SUBJECT: PERRY NUCLEAR POWER PLANT, UNIT 1 - STAFF ASSESSMENT OF INFORMATION PROVIDED PURSUANT TO TITLE 10 OF THE *CODE OF FEDERAL REGULATIONS* PART 50, SECTION 50.54(f), SEISMIC HAZARD REEVALUATIONS FOR RECOMMENDATION 2.1 OF THE NEAR-TERM TASK FORCE REVIEW OF INSIGHTS FROM THE FUKUSHIMA DAI-ICHI ACCIDENT (TAC NO. MF3729)

STAFF ASSESSMENT BY THE OFFICE OF NUCLEAR REACTOR REGULATION  
RELATED TO SEISMIC HAZARD AND SCREENING REPORT  
PERRY NUCLEAR POWER PLANT, UNIT 1  
DOCKET NO. 50-440

Figure 3.3-1: Plot of Staff's and Licensee's Base Case Shear-Wave Velocity Profiles for the Perry site

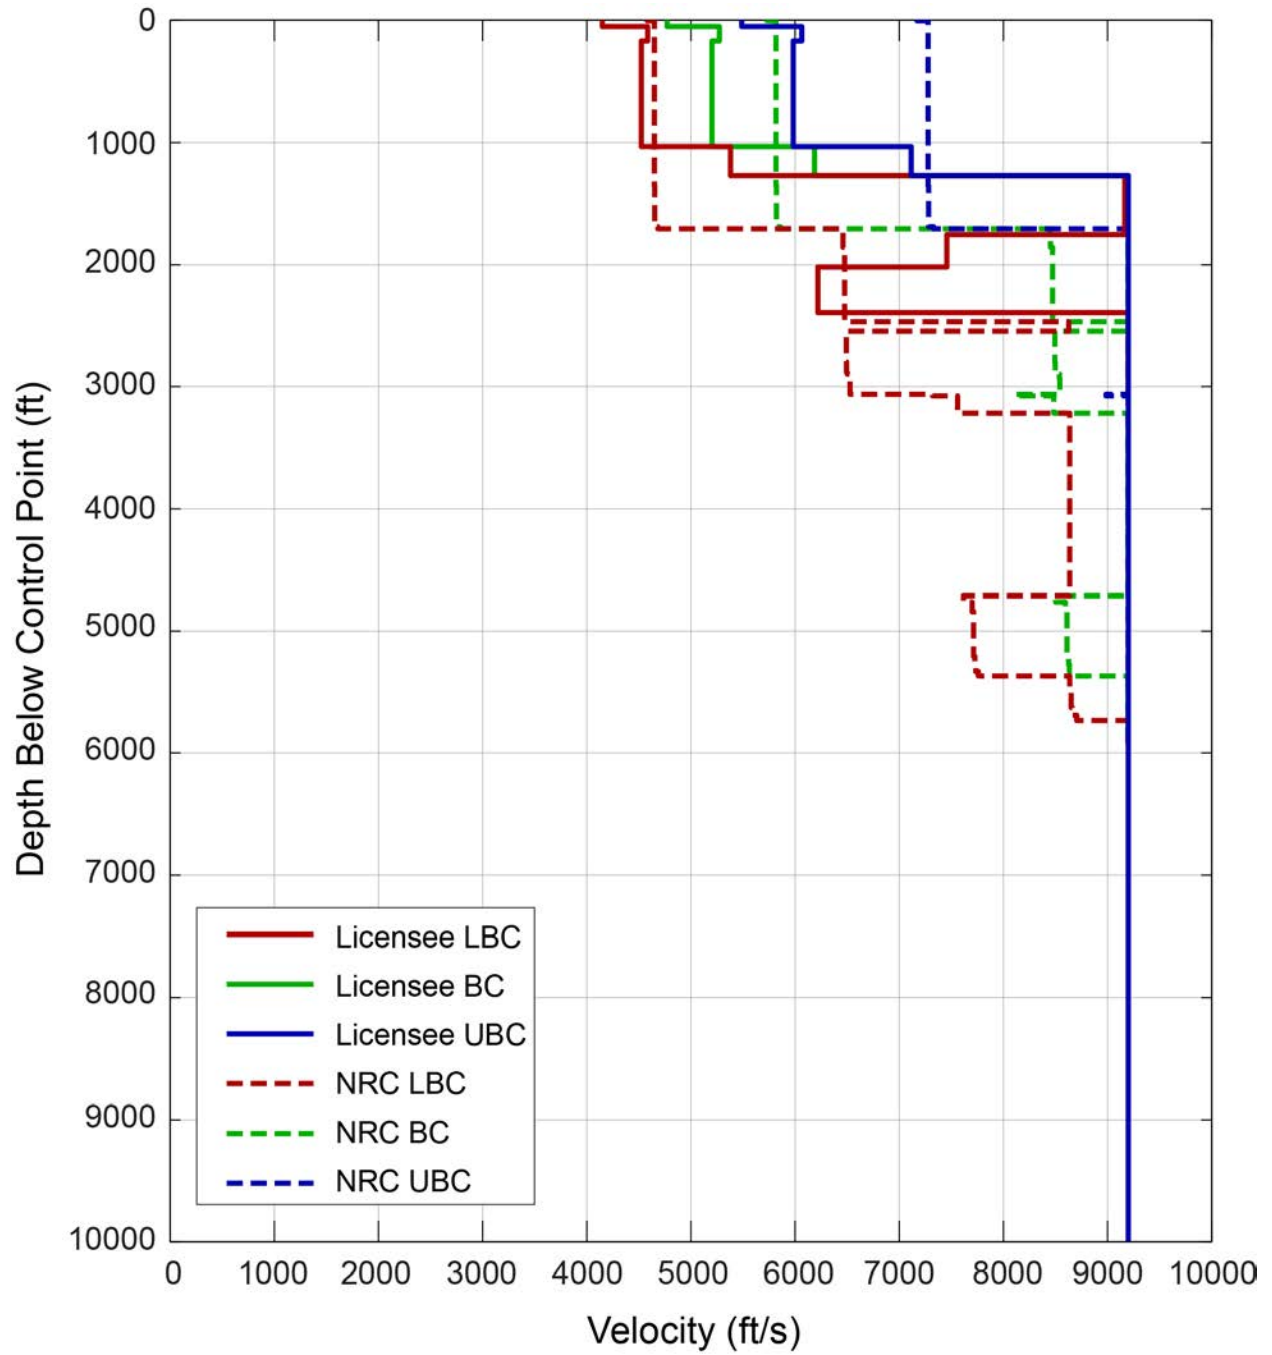
To characterize the subsurface geology, the licensee developed three site base case profiles (P1, P2, P3). The middle, or best estimate, profile was developed using measured shear-wave velocity from the site refraction surveys and cross-hole geophysical investigations. Upper and lower base case profiles were developed using a scale factor of 1.15. Consistent with the SPID, the licensee constrained the upper range base-case profile to not exceed a shear wave velocity of 9,200 ft/s [2,804 m/s]. Figure 3.3-1 of this assessment shows the licensee's three shear-wave velocity base case profiles.

indicated a range of 5,733 ft/s [1,747 m/s] to 9481 ft/s [2,890 m/s] to a depth of 6,060 ft. [1,847 m] below the control point. The NRC staff developed the lower and upper base-case velocity profiles using the estimated natural-log standard deviations of 0.175 to a depth of 1864 ft. [568 m], 0.21 between 1,864 to 3,078 ft [568-938 m], and 0.09 between 3,078 and 6,060 ft. [938-1847 m]. Figure 3.3-1 of this assessment shows a comparison between the NRC staff and the licensee base-case profiles. Although at first glance there seem to be significant differences between the licensee and NRC staff velocity profiles, on average they are similar. The licensee's velocities are generally lower than those of the NRC in the top 1,200 ft. [366 m], but higher at lower depths. The crystalline basement is placed at 6,060 ft. [1,847 m/s] below the control point.

**Figure 3.3-2: Plot Comparing the NRC Staff's and the Licensee's Median Amplification Functions and Uncertainties for two input loading levels for the Perry site**

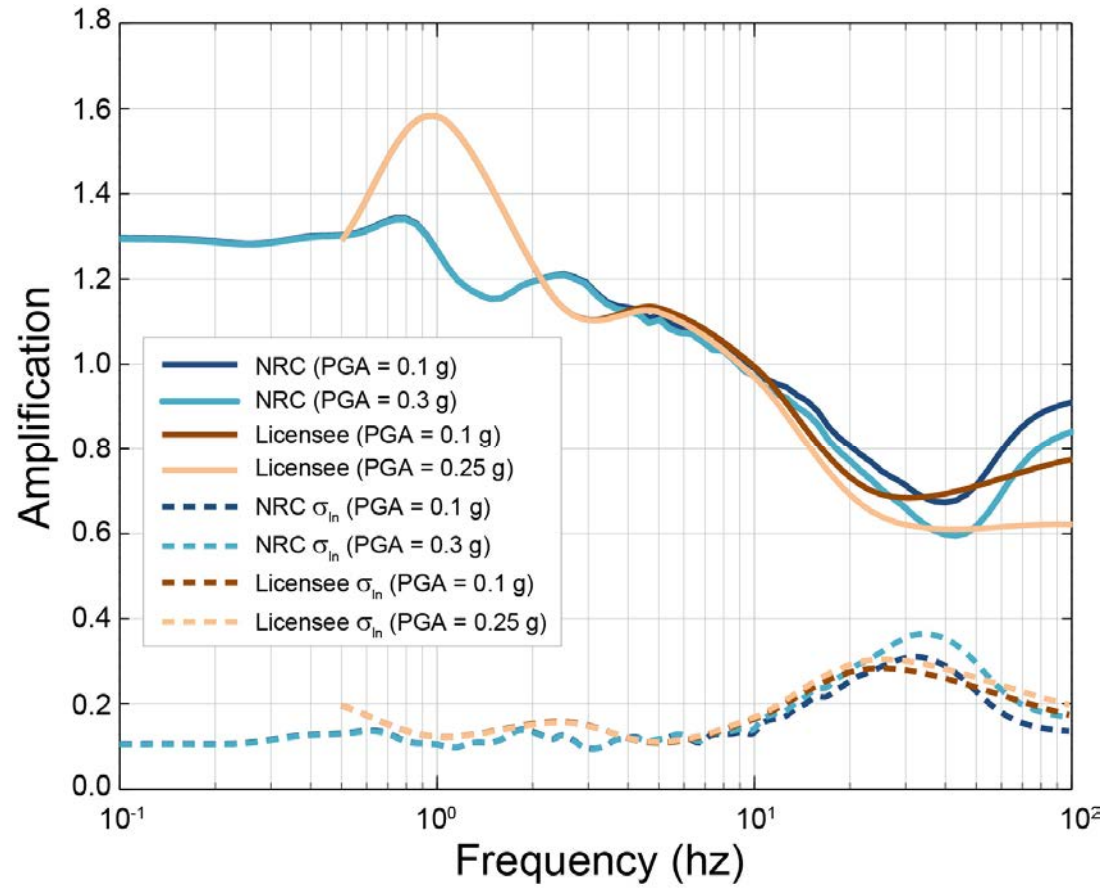
Figure 3.3-2 of this assessment shows a comparison of the NRC staff and the licensee median site amplification functions and uncertainties for 2 of the 11 input loading levels. As shown in this figure, the licensee's amplification functions are very similar to those of the NRC between 2 to 100 Hz, but slightly higher between 0.5 to 2 Hz. Overall, the licensee's approach to modeling the subsurface rock properties and the associated uncertainties result in similar site amplification factors with slight differences. Figure 3.3-3 of this assessment shows a comparison of the licensee and NRC control point hazard curves, which are also very similar.

**Figure 3.4-1: Comparison of the NRC Staff's GMRS with Licensee's GMRS and the SSE for the Perry site**

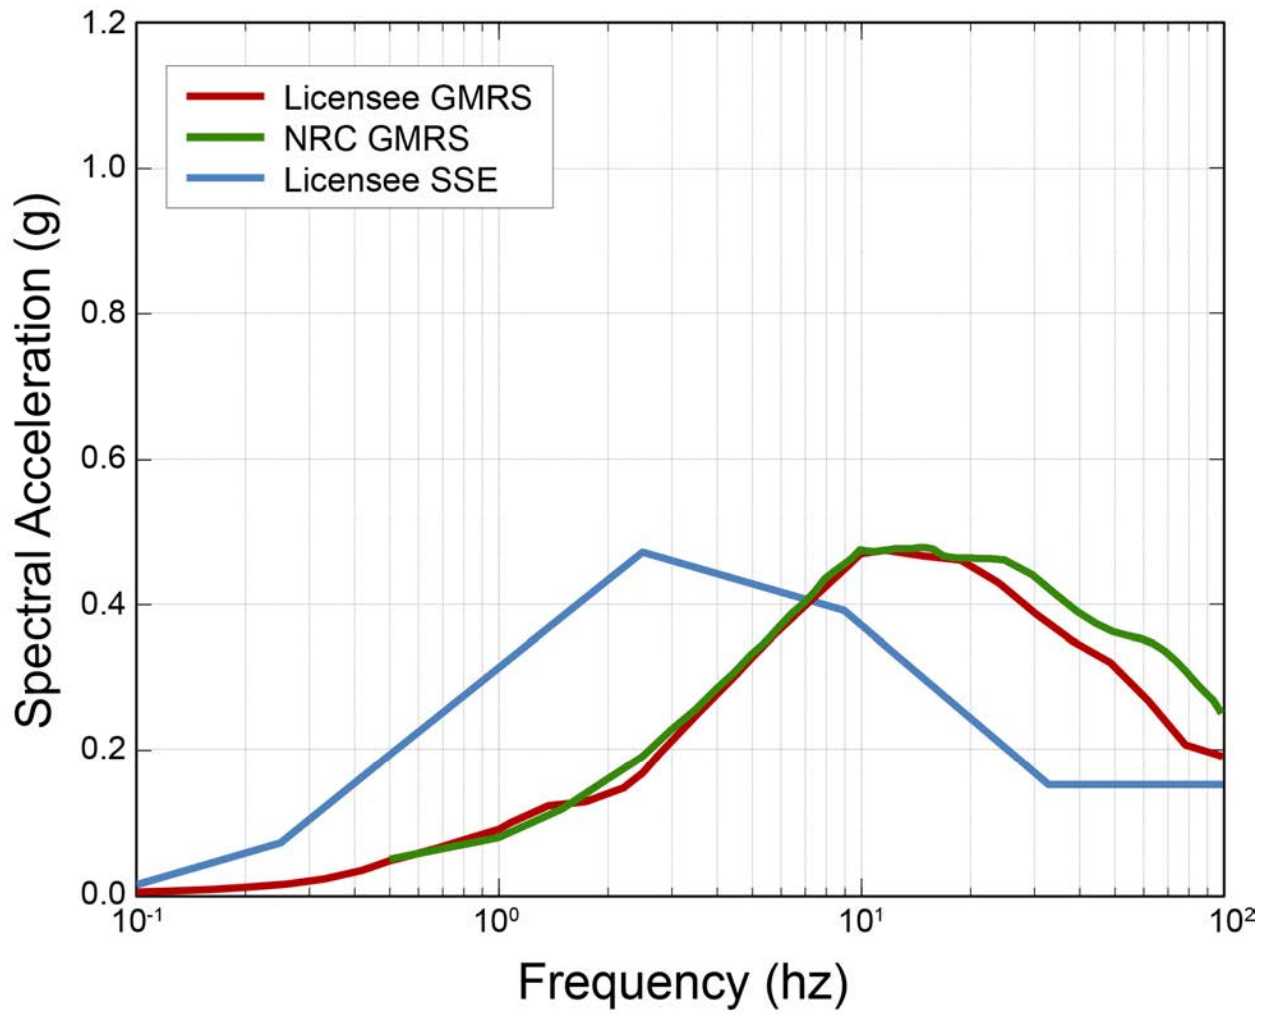
The NRC staff independently calculated the  $10^{-4}$  and  $10^{-5}$  UHRs using the results of its confirmatory PSHA and site response analyses, as described in Sections 3.2 and 3.3 of this staff assessment, respectively. Figure 3.4-1 of this assessment shows a comparison of the GMRS determined by the licensee to that determined by the NRC staff. As shown in Figure 3.4-1, the licensee's and NRC staff's GMRS shapes are generally similar. The licensee's GMRS is somewhat lower than the NRC staff's confirmatory analysis at frequencies between 20 and 100 Hz. As described above, in Section 3.3, the NRC staff concludes that these differences over this frequency range are primarily due to the differences in the site response analyses performed by the licensee and staff. The NRC staff concludes that these differences are acceptable for this application because the licensee followed the guidance provided in the SPID with respect to both the PSHA and site response analysis for the PNPP site.
